Decatur Donald III (Unicorn)

CITY OF LAS VEGAS		DATE:
INTER-OFFICE MEMORANDUM		March 14, 2018
TO: Land Development Services Department of Building & Safety		FROM: Albert Sung, P.E. Flood Control Project Engineer Department of Public Works
SUBJECT:	Drainage Study for:	COPIES TO:
	Decatur Donald III (Unicorn)	Actus
Cross Streets:	SEC of Dorrell Lane & Unicorn Street	Beazer Homes
File Number:	F:\Depot\DSMemos\DS4961A.doc	Bart Anderson, P.E., DevCo
Parcel Number:	125-24-602-001	
Zoning Action:	TMP-63589	
FEMA Flood Zone	YES NO X	
Proposed Storm Drain	YES NO X

The Drainage Study for the subject project has been reviewed and:

FIGURE 7 - EXISTING CONDITION BASIN MAP
DECATUR DONALD III (UNICORN)
BEAZER
CITY OF LAS VEGAS, NV

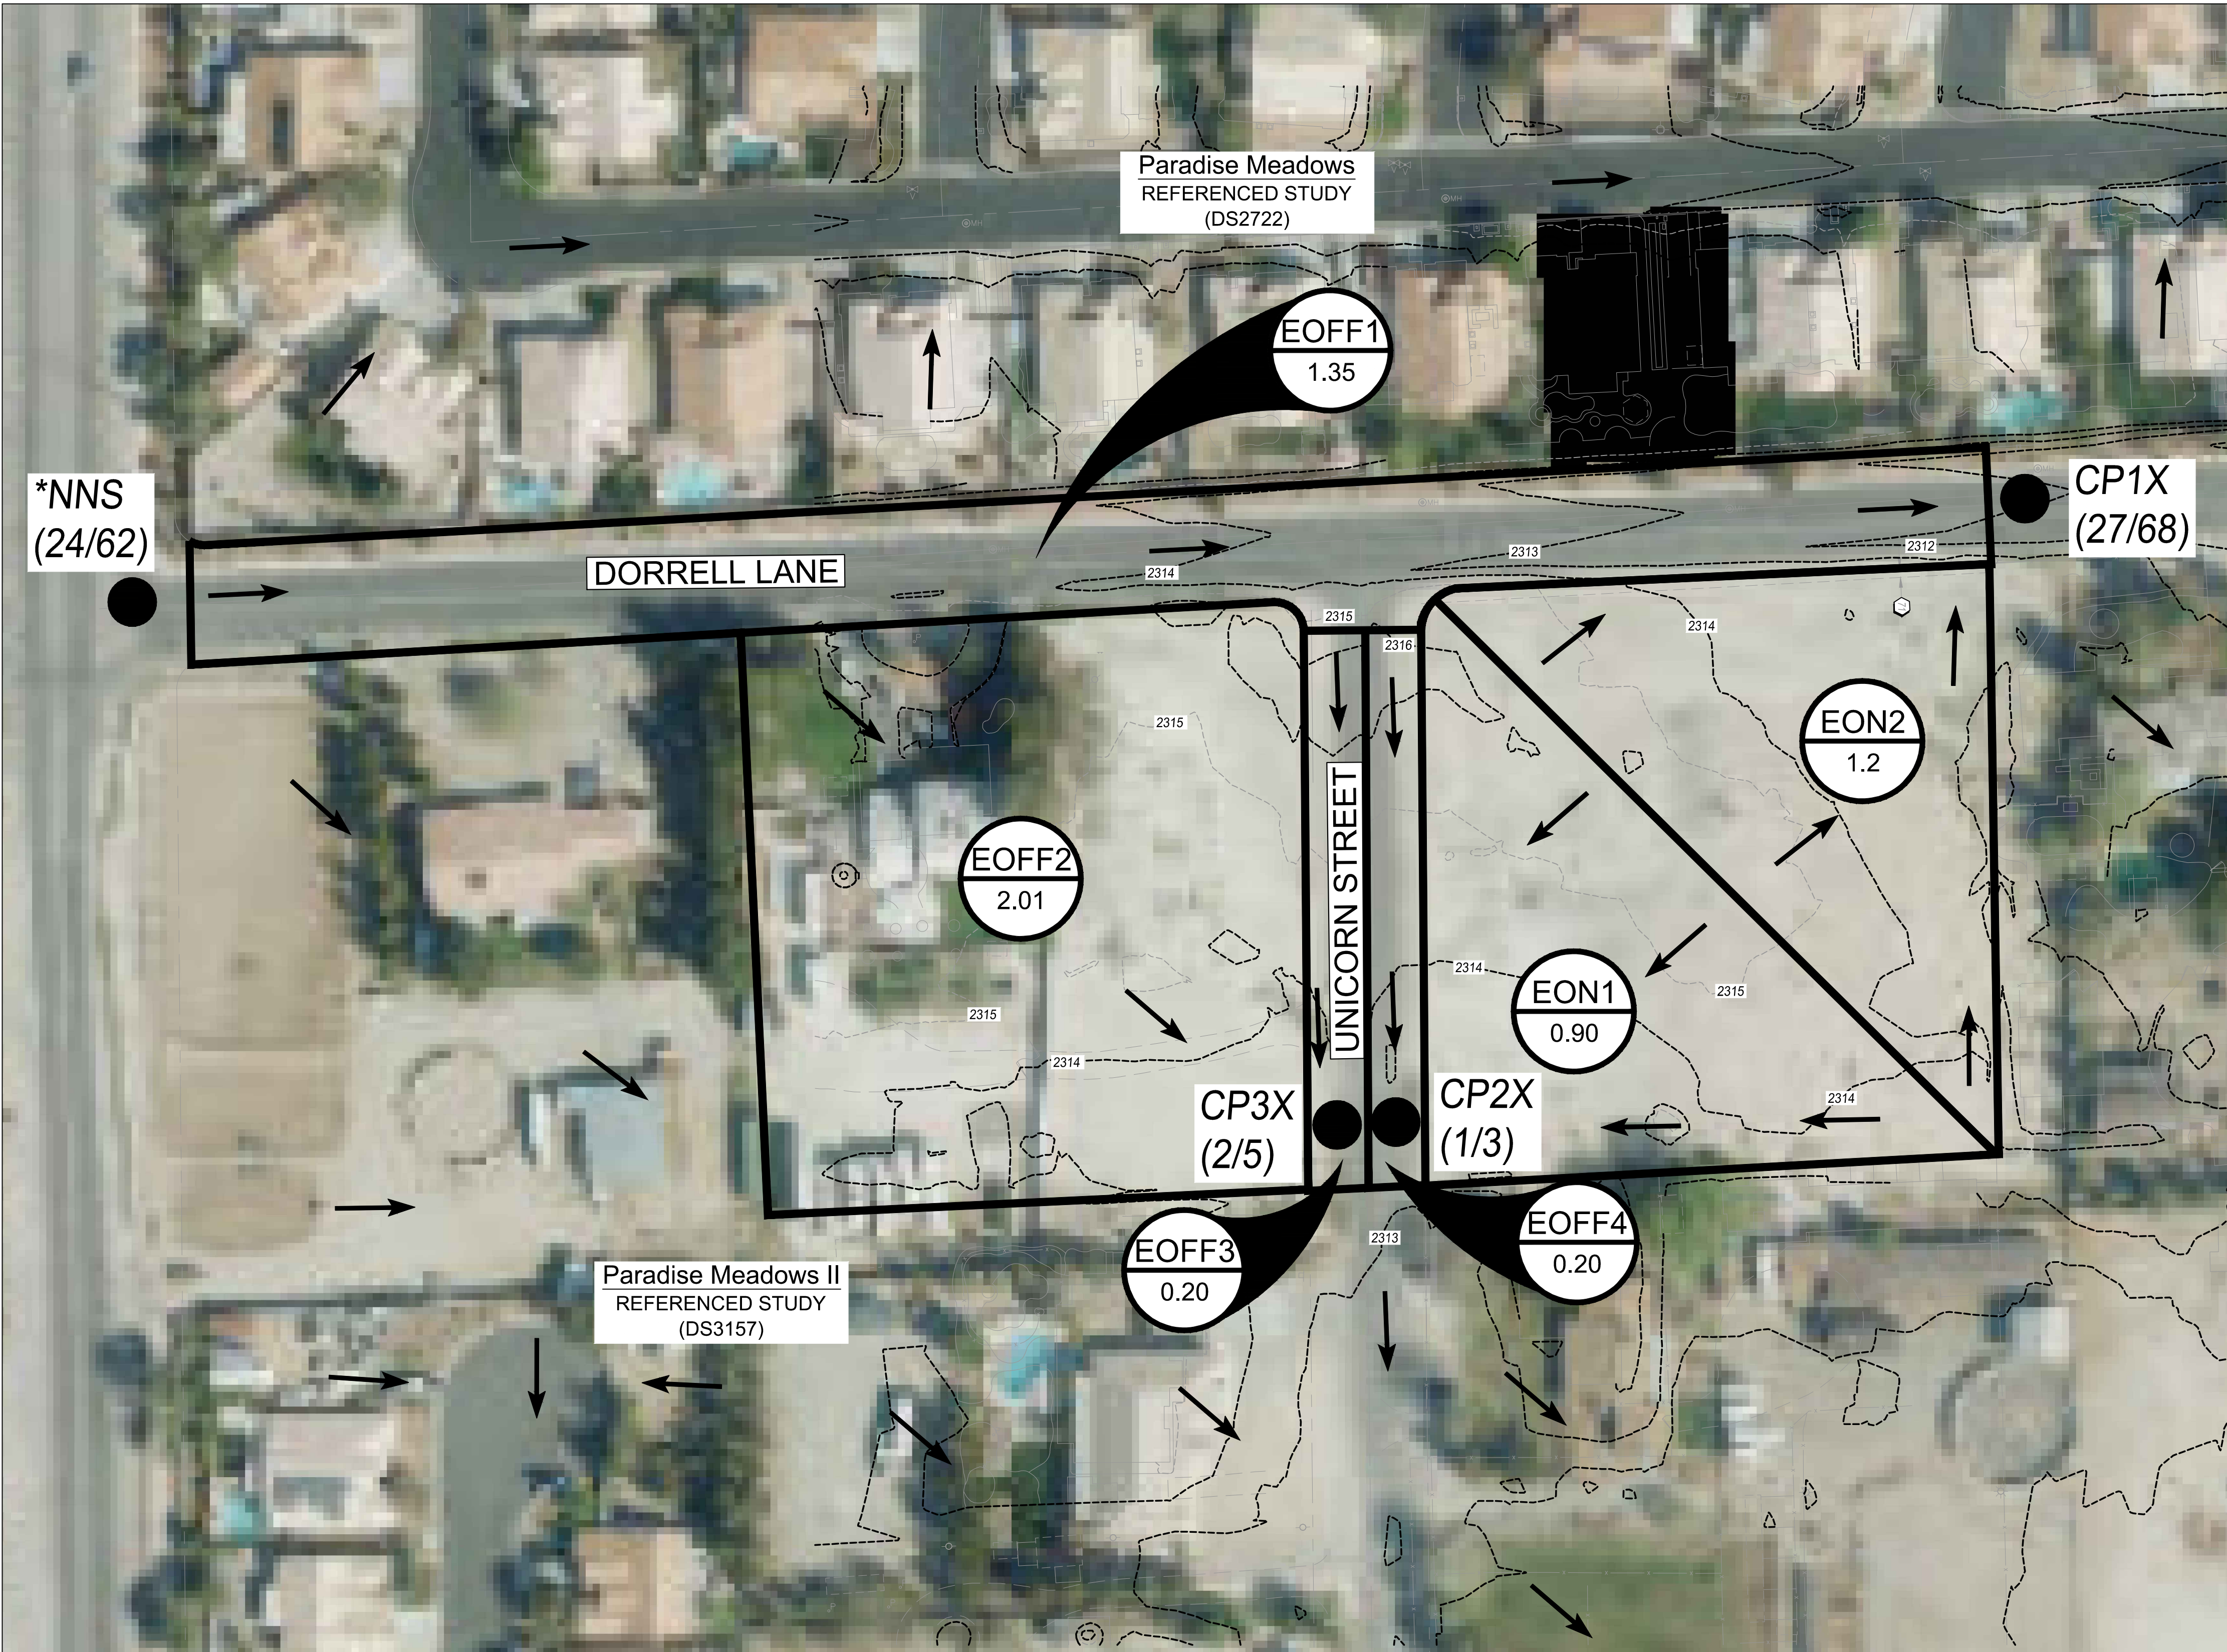
- The values for the onsite basin areas on the figure for EON1 and EON2 do not match the values shown in for the table in Figure 7 Existing Condition Basin Map. For example, EON1 shows 0.90 acre and the table lists the drainage area as 1.05 acres.

7. Figure 7, 8, and 9 legend and labeling do not match, specifically for the basin and combination point labels. Please update the legend to represent the label type/style used.
8. Annotate the existing contour lines on the grading plan to determine how much fill is proposed to the site.
9. Show and identify an existing 24"-storm drain system in *Dorrell Lane* with *City of Las Vegas* recorded drawing number on the grading plan. Show all existing laterals, inlets if any.
10. Label existing finished floor elevations of houses adjacent to the north of *Dorrell Lane* on the grading plan.
11. Private streets must be public drainage easements. Provide a note on the grading plan "Note: All private streets are P.U.E., Public Sewer Easements and Public Drainage Easements to be privately maintained by HOA".

C3

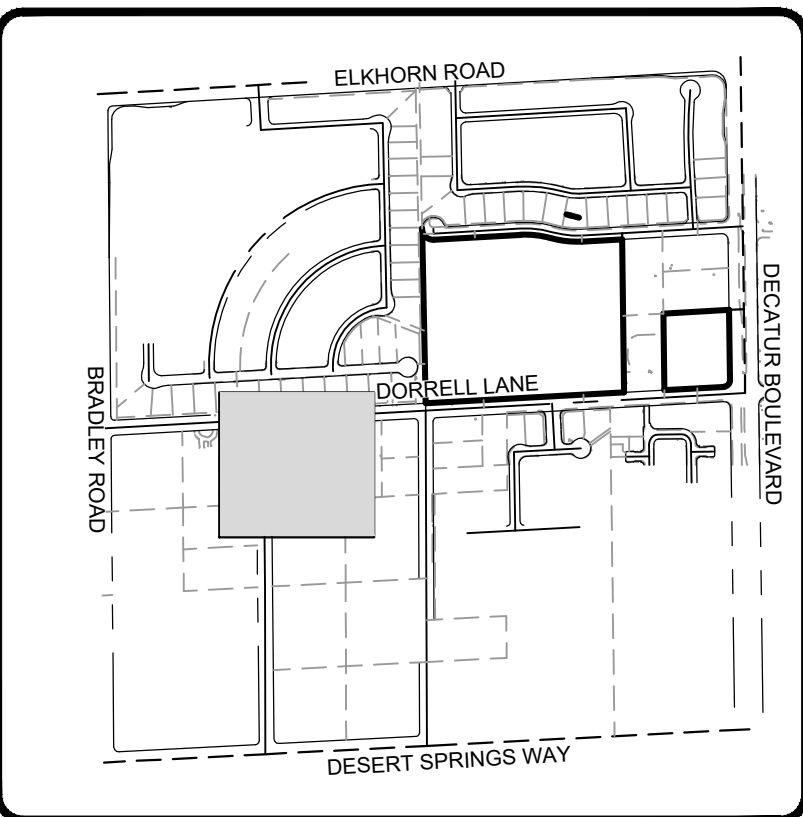
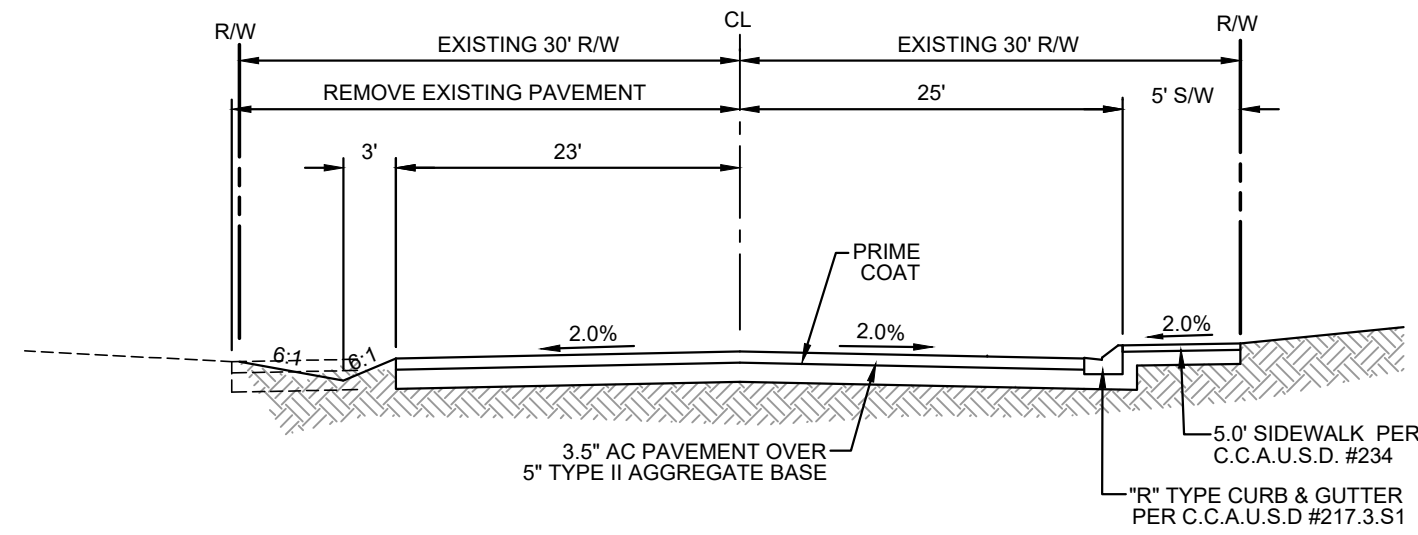
- Sheet C3:** The slopes along the cul-de-sac at the end of *Street A* need to be shown on the grading plan. The minimum allowable slope in a cul-de-sac bulb is 1%. Review and revise accordingly.

- There does not appear to be a curb along the north half of *Dorrell Lane*. However, TC values were shown on the north side. Revise to provide the flow line elevations along the north half of *Dorrell Lane* as opposed to the TC values shown.

- Provide plan and profiles of *Unicorn Street* and *Dorrell Lane* to confirm that the existing highpoints and elevations will not be changed.
- Point out the high point on Unicorn Street to show where the direction of flow changes on the grading plan.
